ECE/TRANS/WP.29/GRE/2007/64 4 September 2007

COLLECTIVE AMENDMENTS Regulations Nos. 6, 7 and 48

<u>Proposal for draft corrigendum to Regulation No. 48</u> (Installation of lighting and light-signalling devices)

Transmitted by the expert from France

"6.5.5.1. **Vertical** angles"

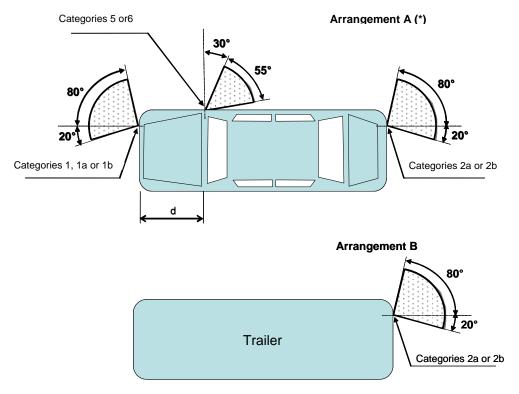
Paragraph 6.5.5.1., amend to read:

Insert new paragraphs 6.5.5.1.1. to 6.5.5.2., to read

- "6.5.5.1.1. Vertical angles above the horizontal for categories 1, 1a, 1b, 2a, 2b and 5: 15°.
- 6.5.5.1.2. Vertical angles above the horizontal for category 6: 30°.
- 6.5.5.1.3. The vertical angle above the horizontal may be reduced to 5° if the optional lamps are not less than 2, 100 mm above the ground.
- 6.5.5.1.4. Vertical angle below horizontal for categories 1, 1a, 1b, 2a, 2b and 5: α ° so that:

where x is the lower height of the lamp above the ground.

6.5.5.1.5. Vertical angles below the horizontal for category 6: 5°.

"6.5.5.3. or, at the discretion of the manufacturer, for M 1 and N 1 category vehicles **/ for front and rear direction-indicator lamps as well as sidemarker lamps:

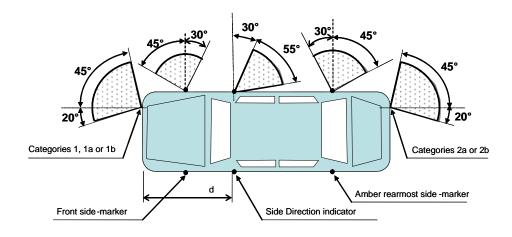
Paragraph 6.5.5.2. (former), renumber as paragraph 6.5.5.3. and amend to read:

Horizontal angles see figure below:

Vertical angle above horizontal: 15°. Vertical angle below horizontal as per 6.5.5.1.4.

To be considered visible, the lamp must provide an unobstructed view of the apparent surface of at least 12.5 square centimetres, except for side direction-indicators of categories 5 and 6. The illuminating surface area of any retro-reflector that does not transmit light shall be excluded.
